A. Section [5.1.8 (GTR) / 7.1.8 (UNR)] – Management of post deployment safety

1. Paragraph 5.1.8.2 (GTR) / 7.1.8.2 (UNR)

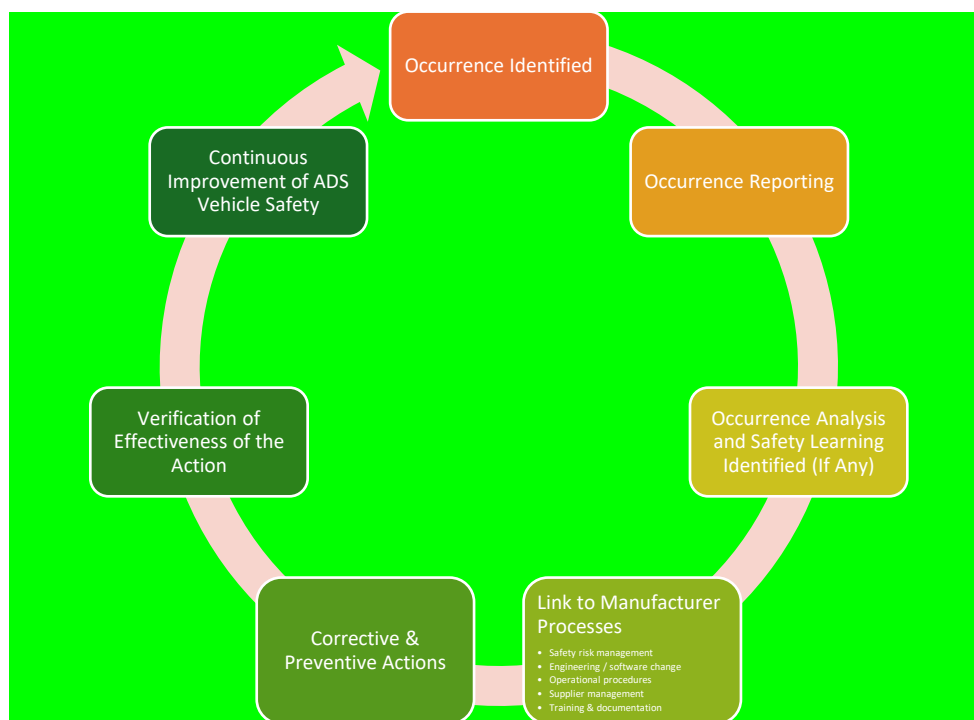
[It is worth clarifying that an occurrence does not always lead to the identification of a safety learning or a corrective/preventive action. In addition, not all the identified corrective/preventive action must be implemented to close the occurrence. As with improving any engineering system the decision of what to fix and how depends on an overall judgment of the consequences and impact of making a change.][RD34]

[The goal of this requirement is to demonstrate that the occurrence analysis is not an isolated activity, but a structured SMS-driven process which ensures proper links among all the manufacturer processes which is the basis for continuous improvement of the ADS vehicle safety.][RD35]
